**RE: 11906 San Antonio Dr. NE
Grading & Drainage Plan
Engineer's Stamp Date: 07/09/21
Hydrology File: E22D007H2**

RE: 11906 San Antonio Dr. NE
Grading & Drainage Plan
Engineer's Stamp Date: 06/10/21
Hydrology File: E22D007H2

Based upon the information provided in your submittal received 06/10/2021, the Grading & Drainage Plan **is not** approved for Grading Permit. The following comments need to be addressed for approval of the above referenced project:

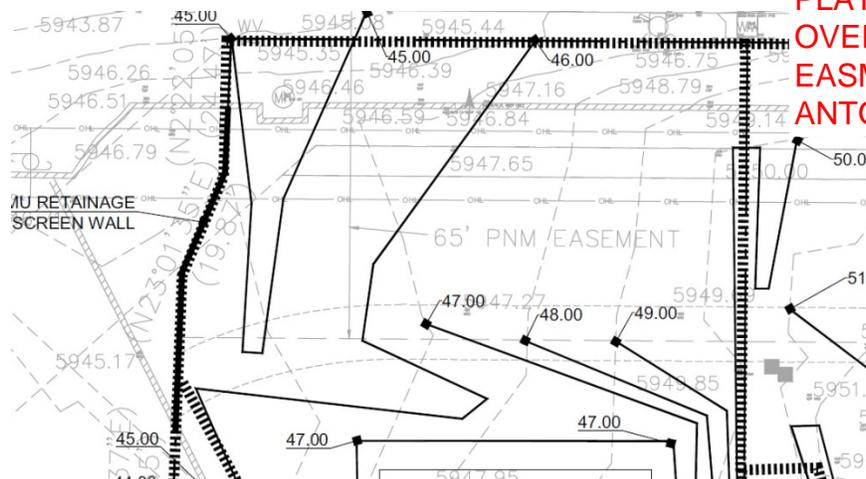
1. Please provide the existing 65 feet PNM Easement in the front of the property. Also please show the existing overhead power lines. (See Below) **ADDED, ACCORDING TO PLAT AND SURVEY IT OVERLAPS THE ACCESS EASEMENT THAT IS SAN ANTONIO**

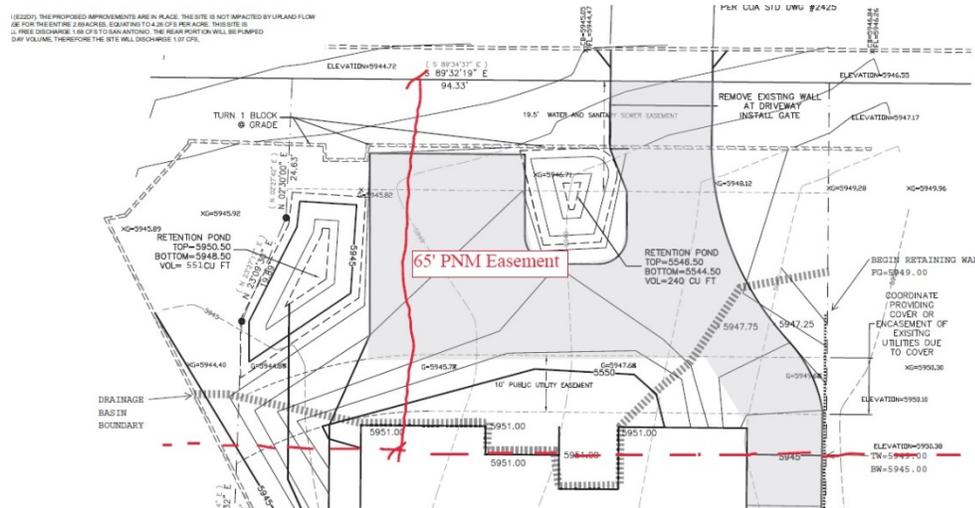
2. The house needs to be relocated out of the existing 65 feet PNM Easement. (See Below) **HOUSE DOES NOT ENCROACH, NORTH EDGE OF 65' EASEMENT DOES NOT CORRESPOND TO PROPERTY LINE, EASEMENT HAS BEEN SHOW PER SURVEY AND PLAT**

- Per the approval letter for Prichard Subdivision dated December 17, 2018 (Attached), Hydrology will need written permission from PNM for any grading within their 65 feet Easement. **IF PLAN IS ACCEPTABLE, PERMISSION WILL BE OBTAINED AND WE PROPOSE AT PAD CERT**
- Also according the approved Conceptual Grading & Drainage Plan for Prichard Subdivision (E22D007H), a retention pond is required to hold the 100yr-6hr storm. (See Below) Therefore this lot needs a retention pond volume of 657 CF. **WE HAVE INCREASED RETENTION VOLUME AS REQUIRED**

DRAINAGE NARRATIVE

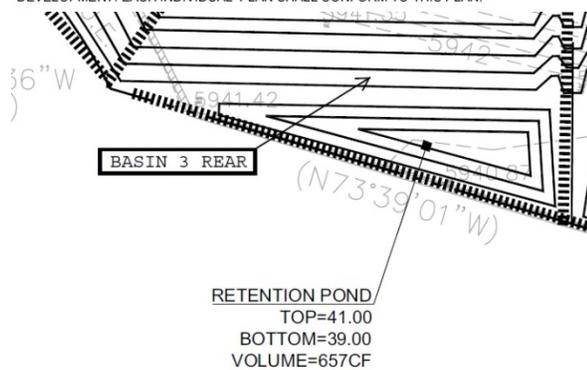
- The proposed drainage narrative provided violated this previous approved Conceptual Grading & Drainage Plan for Prichard Subdivision. (See Below) Therefore this will have to conform with this plan. **WE HAVE REVISED NARRATIVE**
